# HISTORIC AND DESIGN REVIEW COMMISSION

June 01, 2022

**HDRC CASE NO:** 2022-293  
**ADDRESS:** 1024 N CHERRY  
**LEGAL DESCRIPTION:** NCB 512 BLK 25 LOT W 99.55 FT OF 3  
**ZONING:** R-4, H  
**CITY COUNCIL DIST.:** 2  
**DISTRICT:** Dignowity Hill Historic District  
**APPLICANT:** Joseph Munoz  
**OWNER:** Joseph Munoz  
**TYPE OF WORK:** Construction of a rear addition, exterior modifications, fenestration modifications, porch modifications, roof form modifications, window replacement and siding modifications  
**APPLICATION RECEIVED:** May 17, 2022  
**60-DAY REVIEW:** Not applicable due to City Council Emergency Orders  
**CASE MANAGER:** Edward Hall

FRONT ELEVATION

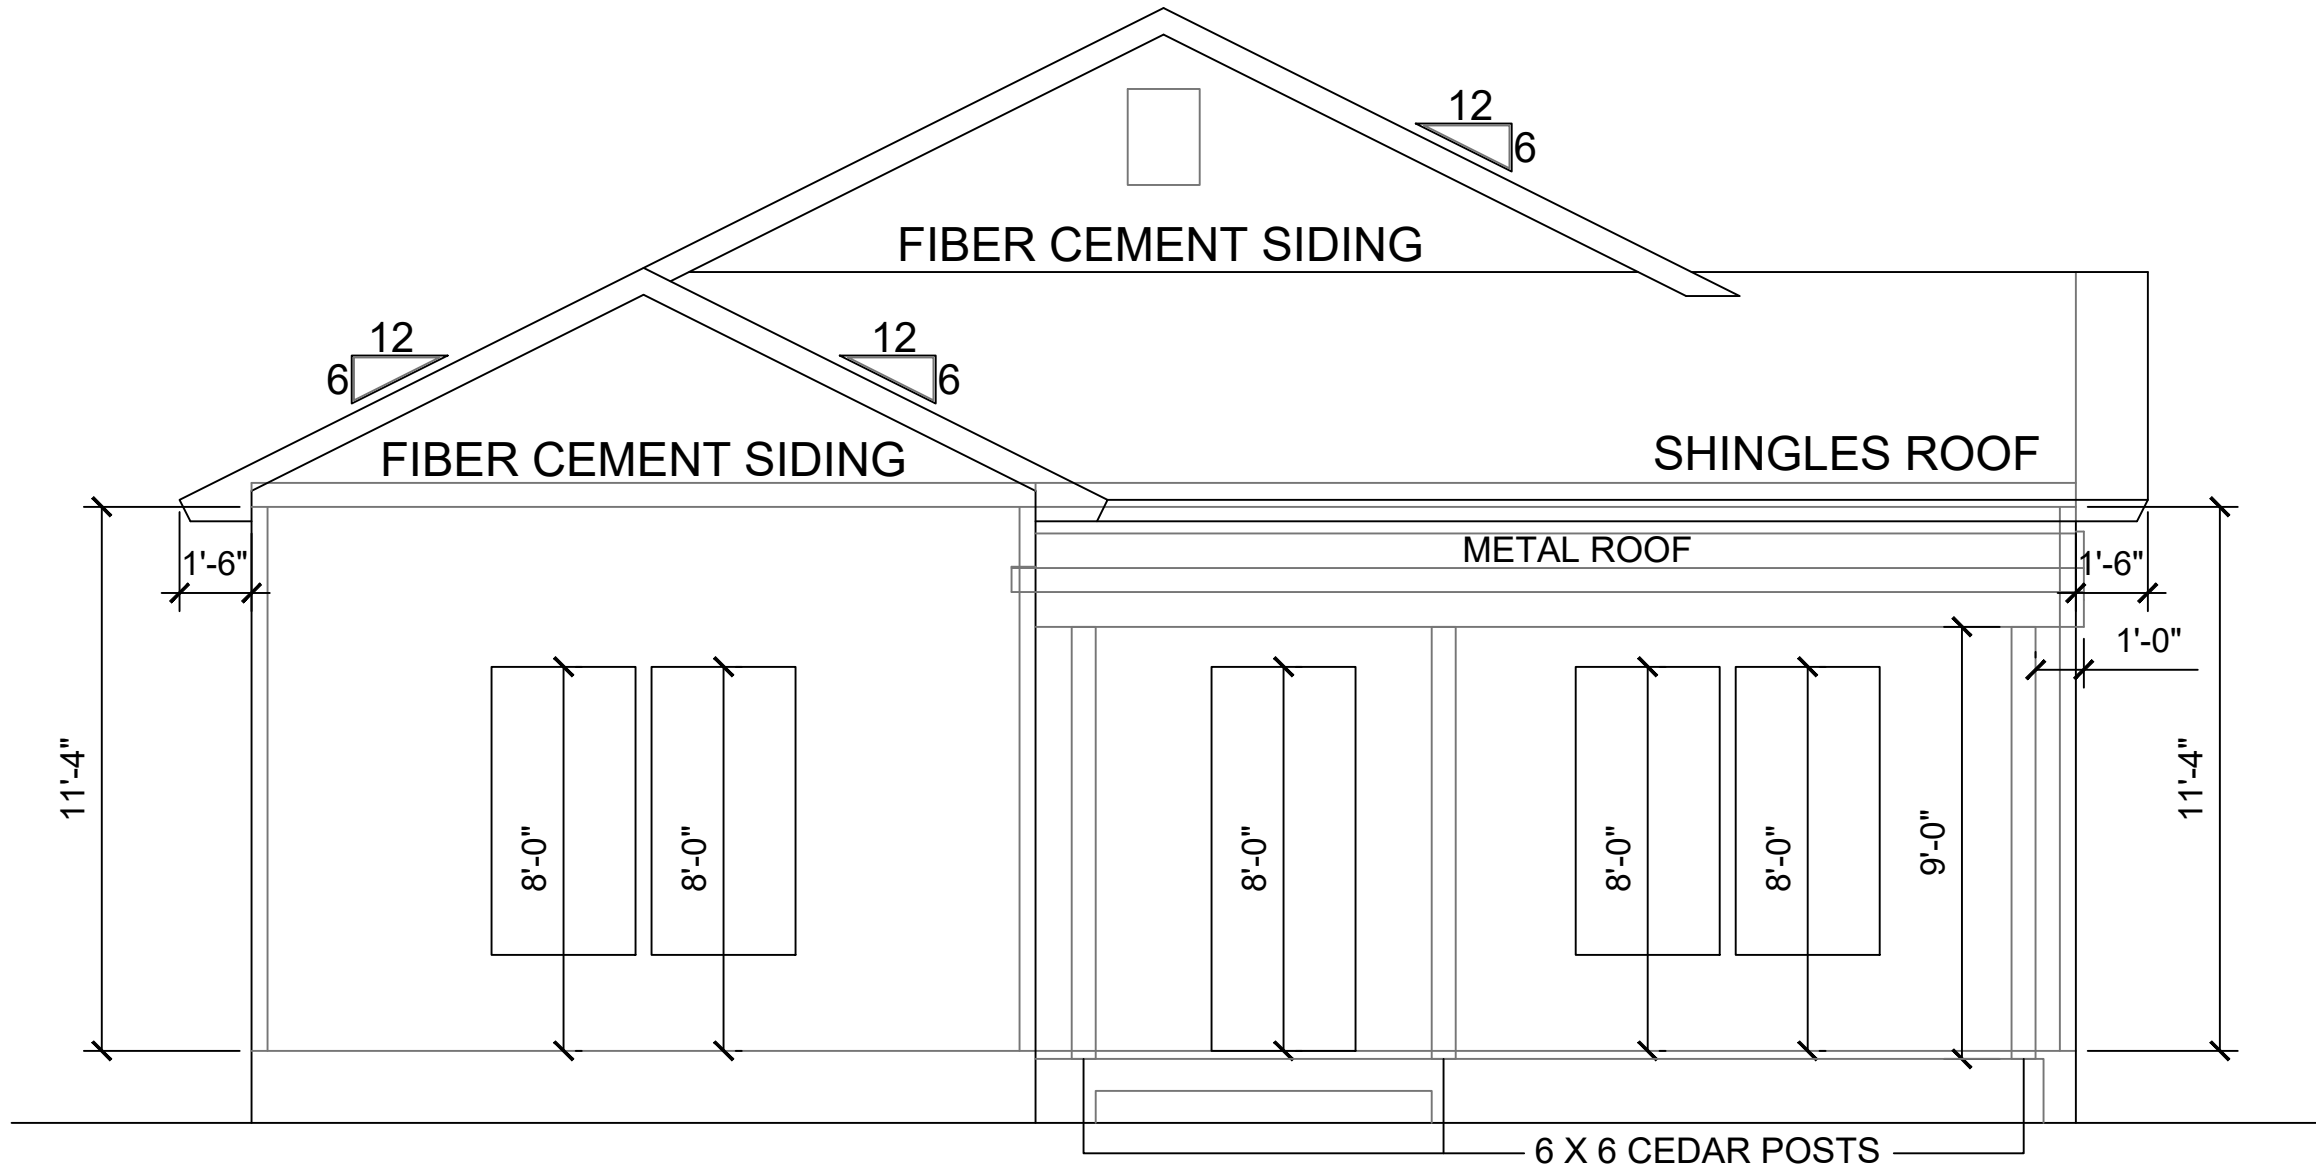
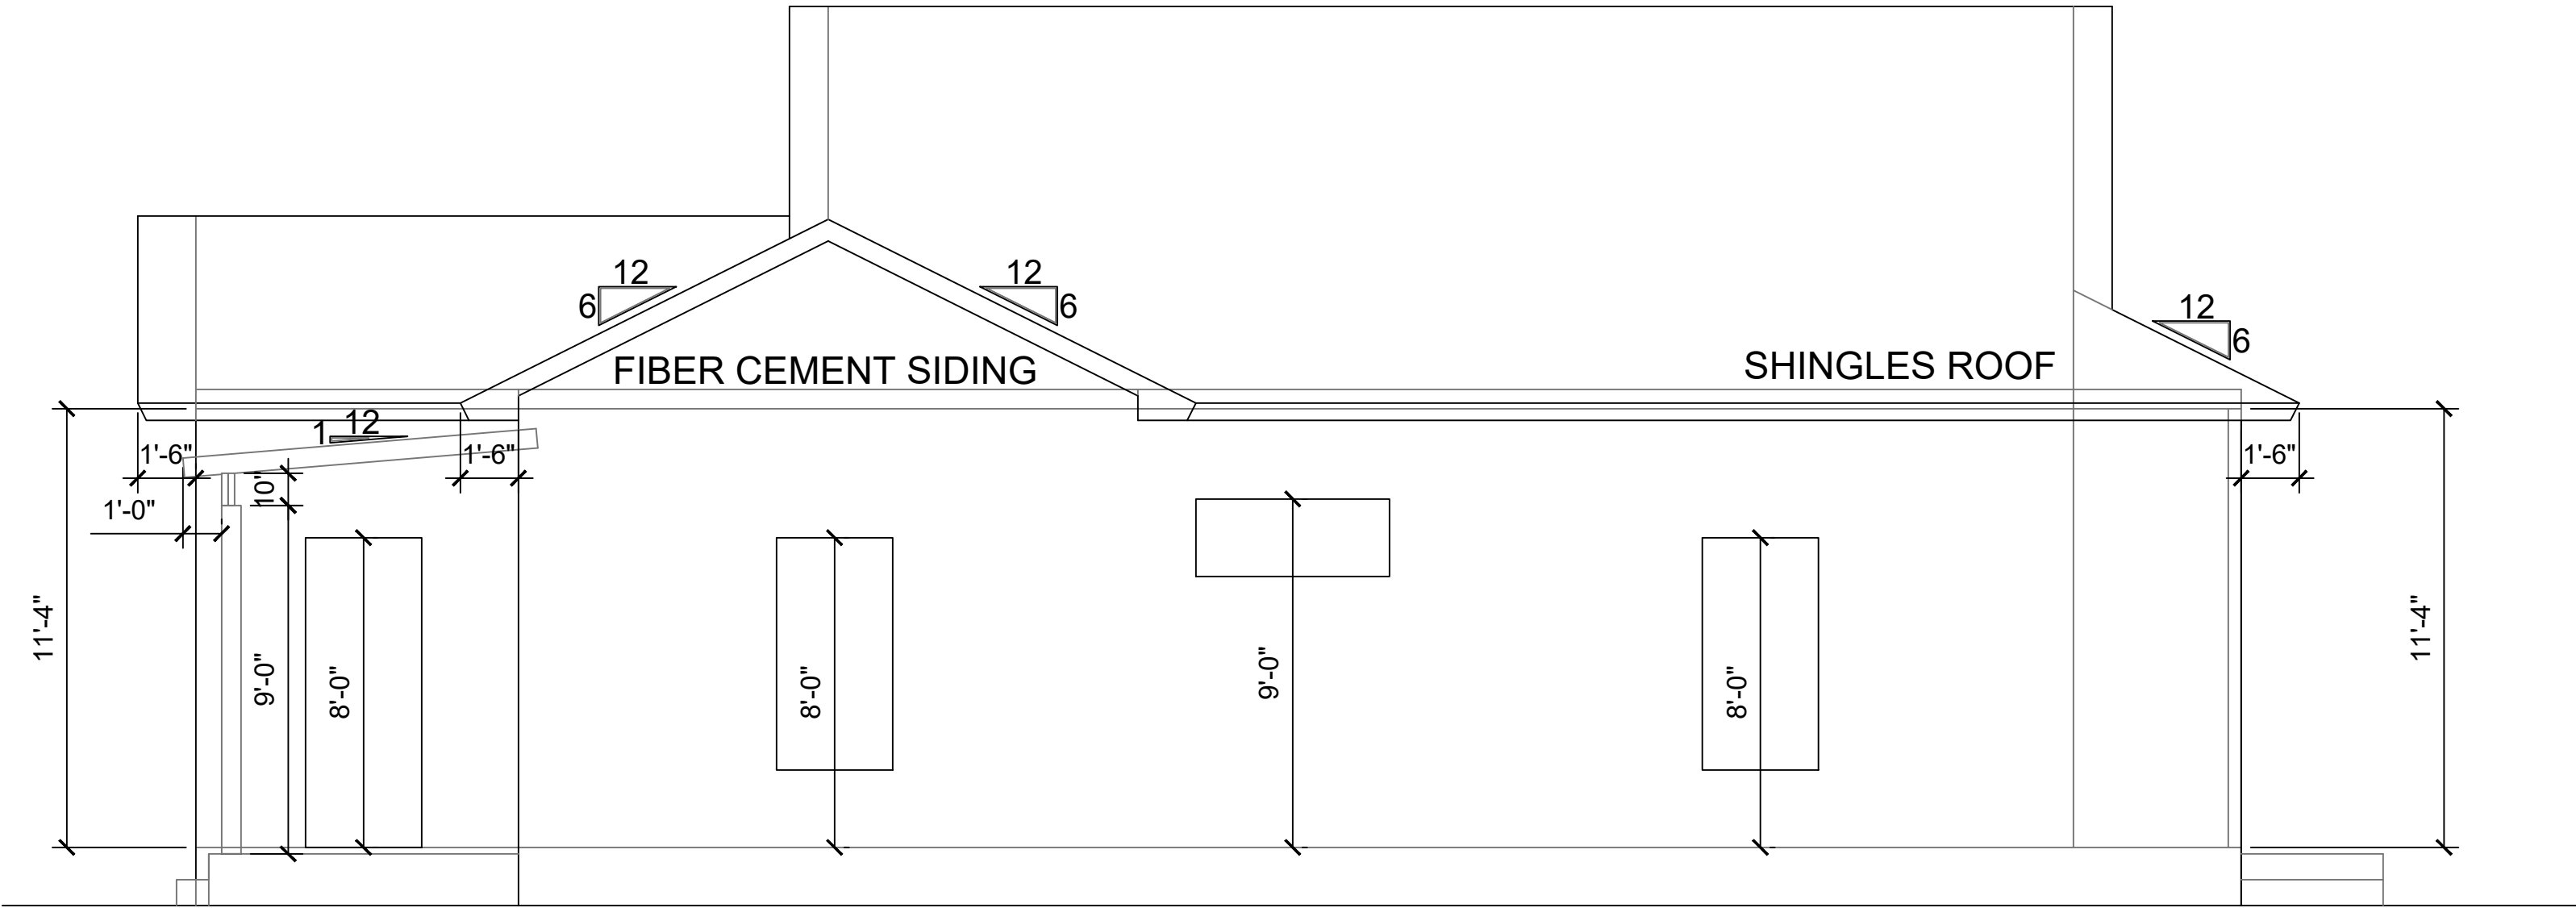
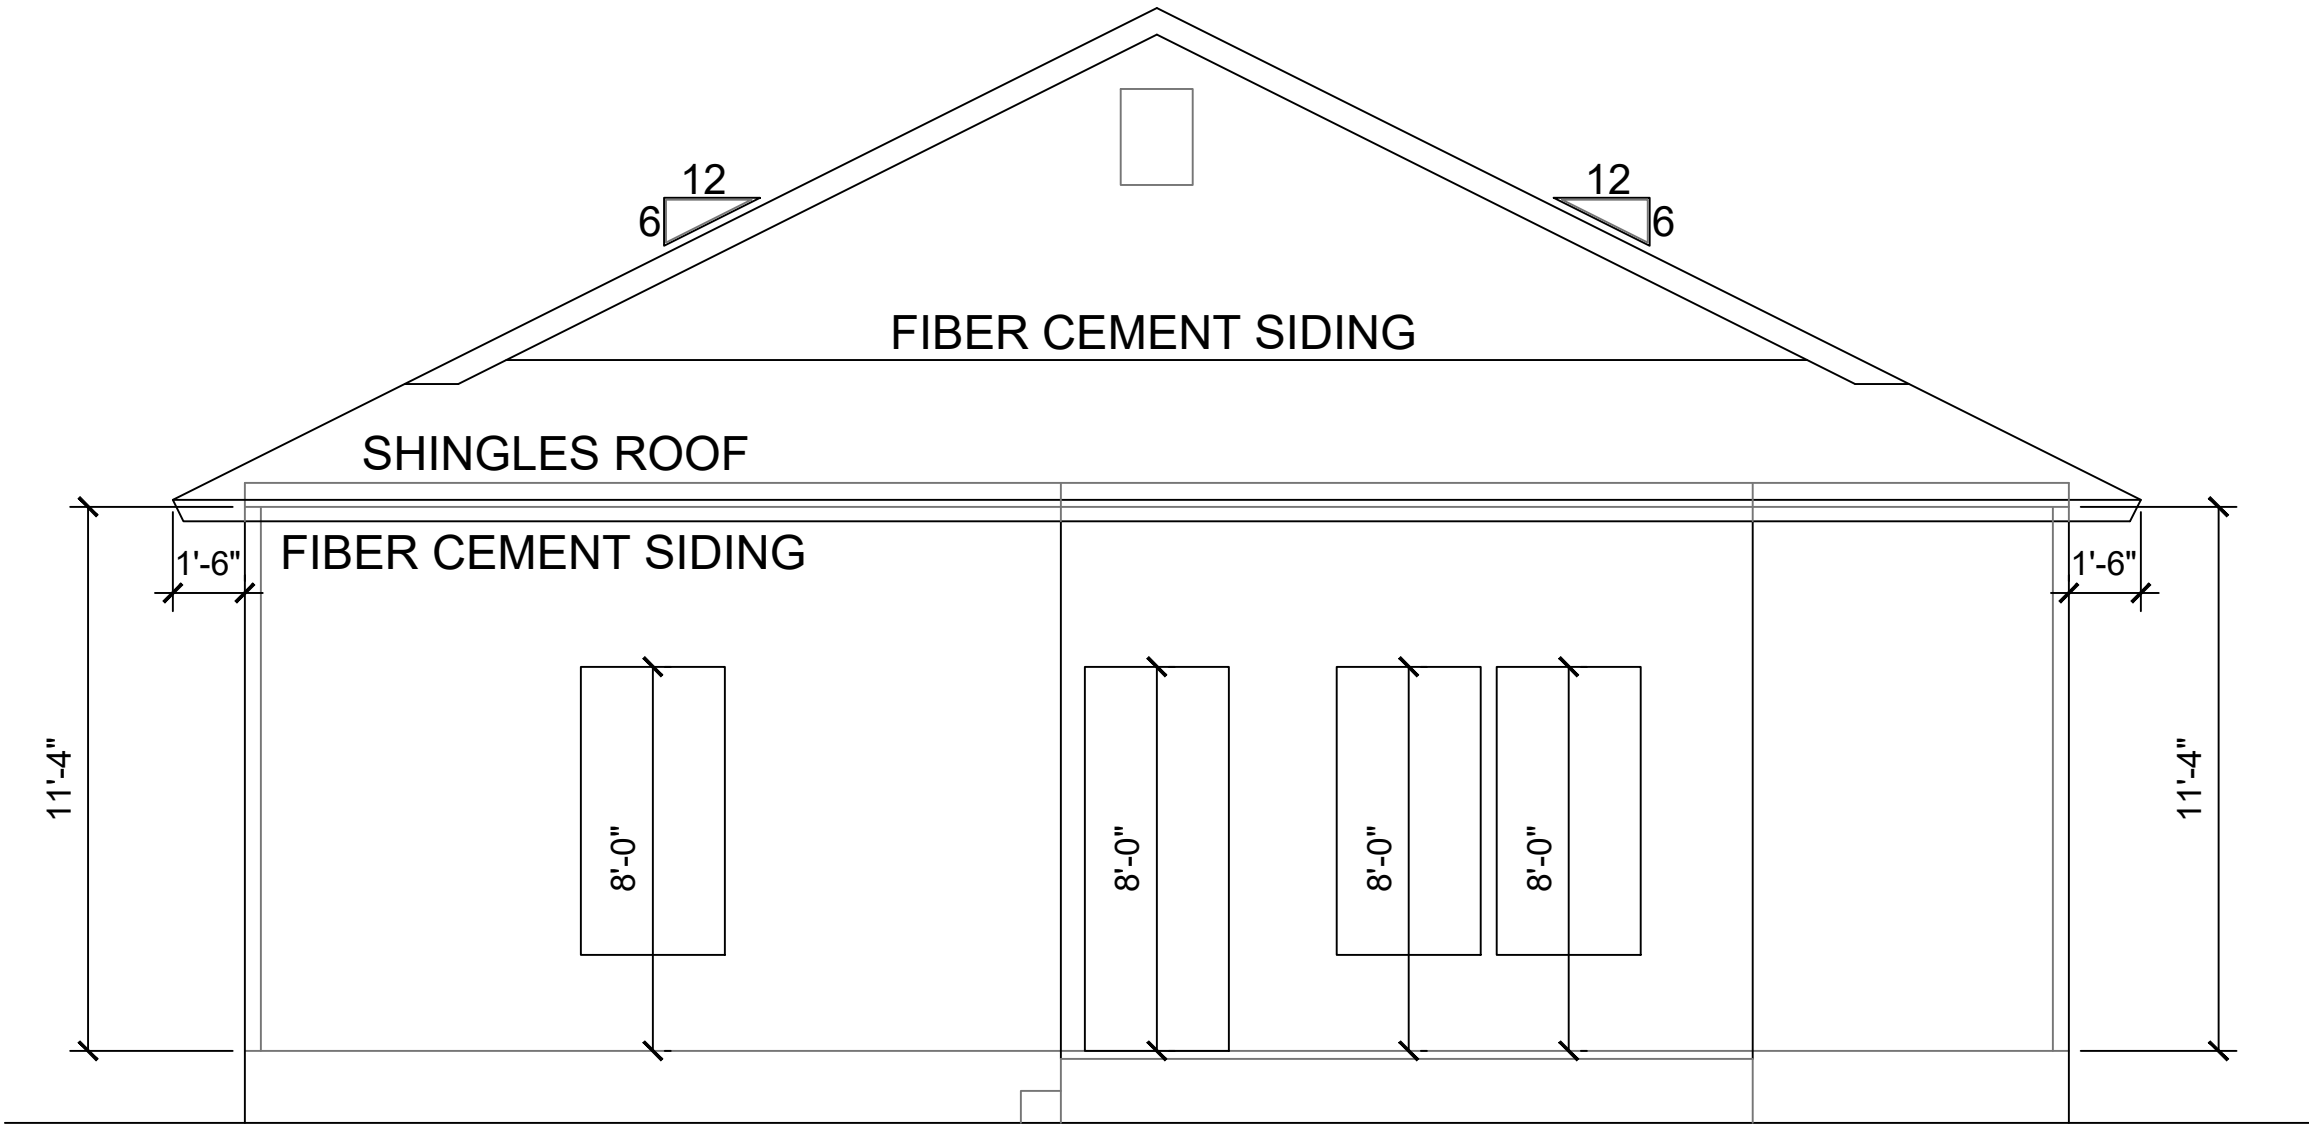
- d. FENESTRATION MODIFICATIONS – The applicant has proposed fenestration modifications that include modifying the existing, historic fenestration pattern of the historic structure by modifying existing door and window openings on the west, north and south facades. Within this request, the applicant has proposed to eliminate the side facing front door within the porch, relocate the street facing front door and modify the head and sill heights, widths, opening locations, and profiles of various windows on each façade. The Guidelines for Exterior Maintenance and Alterations 6.A. note that existing window and door openings should be preserved and that new openings should not be created on the primary façade or where visible from the public right of way. Additionally, the Guidelines note that original opening should not be increased or reduced in size to fit stock window sizes. Staff finds the proposed modifications to be inappropriate and inconsistent with the Guidelines. Staff finds the original sizes, locations and profiles of all windows and doors should be restored.

- f. ROOF FORM MODIFICATIONS – The applicant has proposed to modify the structure's roof form and various architectural elements that are associated with the roof that include eave details, the installation of gable returns, modifications to existing attic vents. The Guidelines for Exterior Maintenance 3.B.ii. notes that the original shape, line, pitch, and overhangs of original roof forms should be preserved. Additionally, eaves and other decorative elements should be preserved. The proposed modifications are inappropriate and consistent with the Guidelines. Staff finds that the original roof forms and attic vents should be reinstalled.

- g. PORCH FORM MODIFICATIONS – The applicant has proposed to make porch modifications including the construction of a new porch roof, a change in porch deck height, and the installation of new porch columns. The existing porch featured modified elements, including modified columns, railings and beams. Staff finds that the existing porch profile should be reconstructed, based on photographic evidence. Columns should feature six inches square with capital and base trim. Fascia and soffit details should be consistent with historic, Folk Victorian examples found within the district. The frieze board should be reinstalled at the previous profile.

- h. SIDING/TRIM MODIFICATIONS – The applicant has proposed to remove the existing, non-original siding and install composite siding with a faux wood grain finish with an exposure of approximately 8 inches as well as install composite trim with faux wood grain. The historic house previously featured a combination of aluminum siding and T-111 siding. The Guidelines for Exterior Maintenance and Alterations 1.B. notes that façade materials that are original should be preserved. When original siding is beyond repair, new siding should be in-kind with the original. Staff finds the composite siding and trim to be inappropriate and inconsistent with the Guidelines. Staff finds the historic structure should feature siding and trim with a profile that is consistent with historic Folk Victorian examples within the district.

greater than that of the historic structure, resulting in a front facing gable that rises above the historic structure's ridge line. Staff finds the proposed roof form to be inappropriate and inconsistent with the Guidelines.

- ii. That the frieze board be reinstalled at the previous profile.
2. Staff does not recommend approval of item #2, modifications to the original fenestration pattern including both windows and doors, based on finding d. Staff recommends the original sizes, locations and profiles of all windows and doors be restored.

4. Staff does not recommend approval of item #4, modifications to the historic structure's roof form based on finding f. Staff recommends that the original roof forms and attic vents be reinstalled.

5. Staff does not recommend approval of item #5, modifications to the historic structure's porch form based on finding g. Staff recommends the existing porch profile be reconstructed, based on photographic evidence. Columns should feature six inches square with capital and base trim. Fascia and soffit details should be consistent with historic, Folk Victorian examples found within the district.

6. Staff does not recommend approval of item #6, siding replacement and trim replacement with composite materials, based on finding h. Staff recommends that the historic structure feature siding and trim with a profile that is consistent with historic Folk Victorian examples within the district. Siding and trim should be wood.
